Improved Info Center Backlighting

SS-2225
 Rev: n/a

NEW BLACK AND WHITE
 STN INFO CENTER
 OPTREX

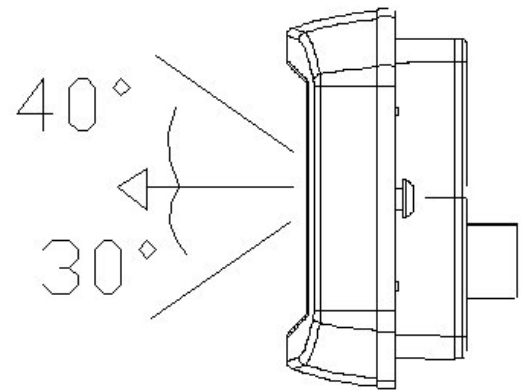
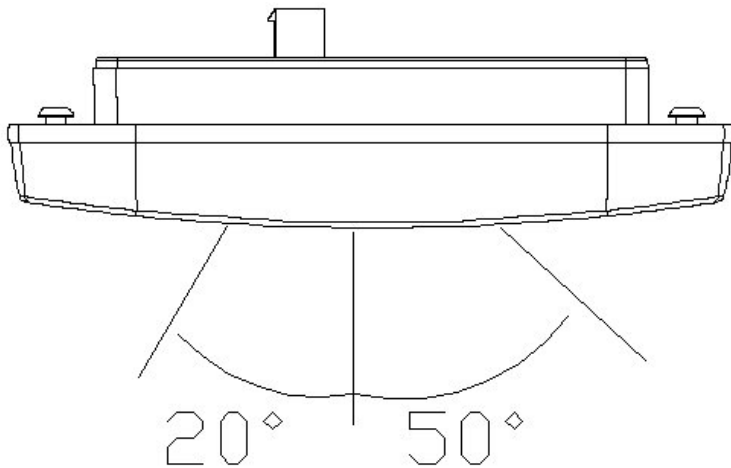
Freightliner Custom Chassis announces the availability of a new product improvement Info Center that uses a black/white Super Twisted Nematic module with film retardation (FSTN) for wider viewing angle and high black and white contrast. The original Info Center was a Graphic LCD Module display that used a green/black Twisted Nematic (TN) technology.

NEW Improved Viewing Angles

- 1. Freightliner p/n KYS-15391020711 – direct parts supercession for original part KYS-15391018101.*
